Access Compliance Report Public Rights-of-Way (Curb Ramps)

Intersection ID: 10013271 Main Street: MALLARD_CREEK_RD Cross Street: N/A Location: S

ADA ID: 54BF8F40E98A Ramp Type: Perp Initial Pass/Fail: Fail Overall Compliance: No Severity Score: 8.75

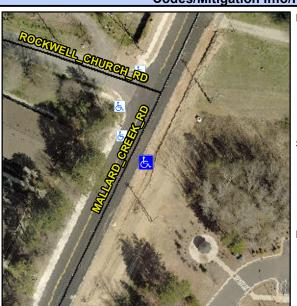
Not Found, R304.5.1

Field Measurements/Component Compliance						
	Compliance Description		Data	Compliance Description		Data
	N/A	Ramp Length (in)	36.0	Yes	Ramp Slope (%)	5.6
	No	Ramp Width (in)	47.5	Yes	Ramp XSlope (%)	1.3
	N/A	Flare Type LT	N/A	N/A	Flare Type RT	N/A
	N/A	Flare Slope LT (%)	N/A	N/A	Flare Slope RT (%)	N/A
	N/A	Flare Traversable LT?	N/A	N/A	Flare Traversable RT?	N/A
	N/A	Landing Length (in)	N/A	N/A	DWS Provided?	N/A
	N/A	Landing Width (in)	N/A	N/A	DWS Contrast?	N/A
	N/A	Landing Slope (%)	N/A	N/A	DWS Length (in)	N/A
	N/A	Landing X Slope (%)	N/A	N/A	DWS Full Width?	N/A
	N/A	Landing Curb? (Y/N)	N/A	N/A	DWS Offset (in)	N/A
	N/A	Shared Landing?	N/A			
	N/A	Gutter Ponding?	N/A	N/A	Gutter Slope (%)	N/A
	N/A	Gutter Lip Ht (in)	N/A	N/A	Gutter X Slope (%)	N/A
	N/A	Painted X Walk1?	No	N/A	Painted X Walk2?	N/A
		X Walk 1 Direction	To NW		X Walk 2 Direction	N/A
	N/A	X Walk 1 Width (in)	N/A	N/A	X Walk 2 Width (in)	N/A
		X Walk 1 Slope (%)	1.2		X Walk 2 Slope (%)	N/A

Remove & Replace Entire Ramp.
